Flawed Reactor Pressure Vessels in the Belgian NPPS Doel 3 and Tihange 2

Comments on the FANC Final Evaluation Report 2015

Ilse Tweer
Materials Scientist, Consultant

January 2016

Figure 4.29

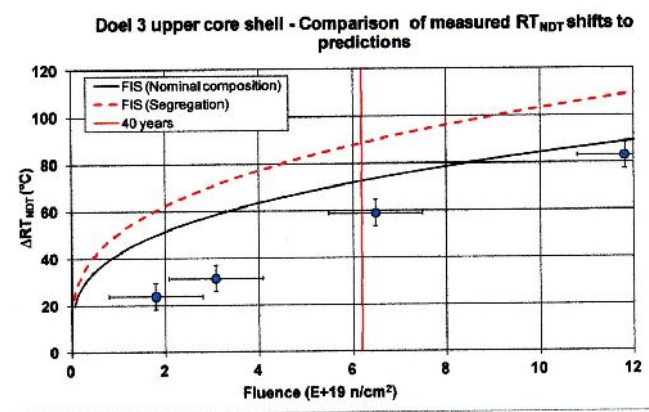
By definition a predictive trend curve is supposed to be the enveloping bound for all tested similar steels. All surveillance data (except the value for very high fluence) including the measuring scatter ranges are below the FIS curve as can be seen in the left diagram, below (figure 4.29, Electrabel Safety Case 2012, page 67.)

Remark: the experimental data differ in the figures from 2012 (FIS curve) and 2015 (the new trend curve): compare for instance the third D3 point from the left (in 2012 ΔRT_{NDT} is slightly below 60°C, in 2015 slightly above). Keeping in mind the experimental scatter, this difference is in fact negligible, but remarkable.

Figure 5.15: CHIVAS-10 results for D3 UCS and D3H1 compared to RPV Surveillance results and to RSE-M prediction.

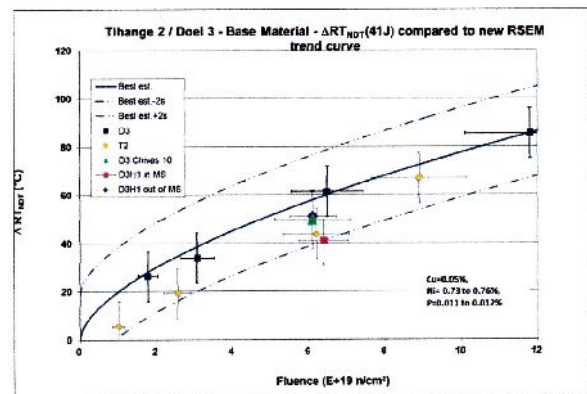
The new predictive curve designed by Electrabel is shown to fit the surveillance data from D3T2 “perfectly” can be seen in the right diagram below (Electrabel Safety Case 2015 figure 5.15, page 50), this figure shows that the experimental data and the scatter are not enveloped by the trend curve, the 2σ standard deviation is necessary for enveloping.

The inherent safety margin by using the FIS formula is completely lost by the use of the new Electrabel trend curves, because the deviation lines do not appear anymore in the curves to be used for SIA.

This demonstrates that new predictive trend curves are certainly not “very conservative”, they are fitted to the given D3T2 data. The additional shift of RT_{NDT} ($RT_{NDT,init,segr} + RT_{NDT,VB395} + M$) that is supposed to be a safety margin in the magnitude of the observed higher embrittlement in the VB395 samples seems to be designed in way that the limiting 132° for RT_{NDT} will not be reached before end of life.

Figure 11: Shift in RT_{NDT} ($\Delta T=41J$) versus fluence (LS = 'Less Segregated Zone', OF = 'out of flakes', BF = 'Between Flakes')

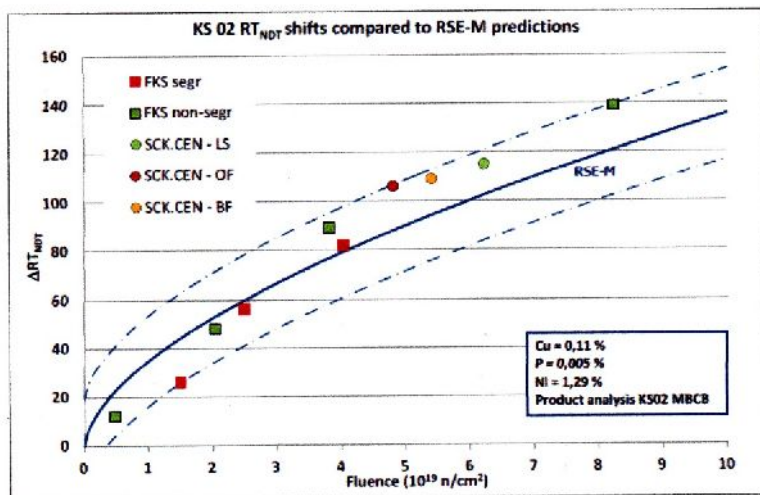
The RT_{NDT} shifts of the German RPV steel sample KS02 (as a comparable steel) should also be enveloped by the new predictive trend curve. The figure 11 in the SCP report on the Safety Case 2015 (page 21) shows that most of the experimental data points are above the curve.

The last irradiation campaign was performed with samples from a German hydrogen flakes containing similar steel (FKS: Forschungsvorhaben Komponentensicherheit) for further comparison. The measured RT_{NDT} shifts of this campaign also exceeded the trend curves by up to 20°C⁶³ (figure 11, page 21).

Figure 5.27: RT_{NDT} trend curves for the D3T2 core shells used in the SIA.

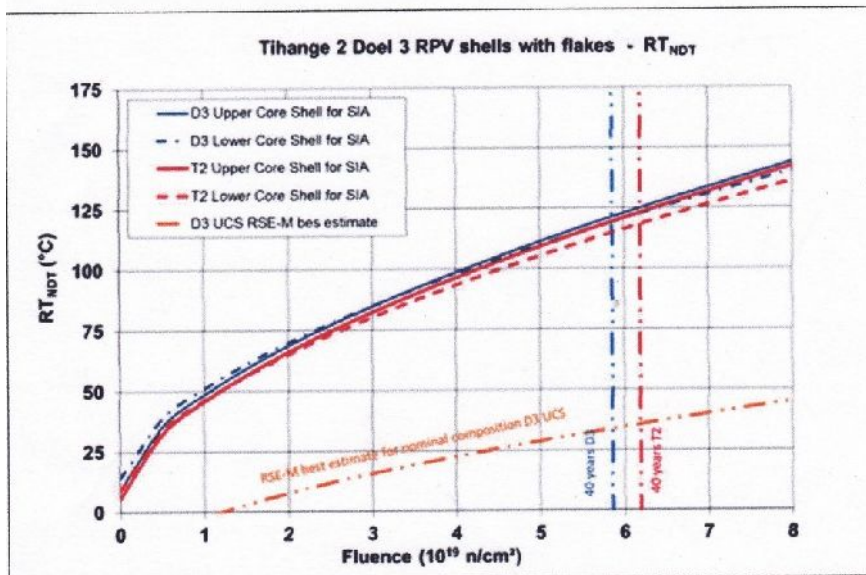
The figure 5.27 (page 71) in the Electrabel Safety Case 2015 allows the estimation of the used extra shift of RT_{NDT} supposed to be in the magnitude of the VB395 embrittlement at EOL: Assuming that the shift due to the FANC request is about 10°C, M about 15°C, the remaining difference is about 55-60°C. As derived in the preceding section the shift of the VB395 Master Curve is about 100°C. That means that the extra shift is de facto a random value, very probably fitted to the requirement that RT_{NDT} remains below 132°C until end-of-life. The figure shows that the trend curves to be used for SIA comply with this requirement.

- The safety margin “in the magnitude of the VB935 embrittlement” to be used for the structural integrity assessment is not quantified. The figures show that this extra margin might only be an adjustment to the requirement that RT_{NDT} has to remain below 132°C until end-of-life and by far smaller than the observed VB395 embrittlement.
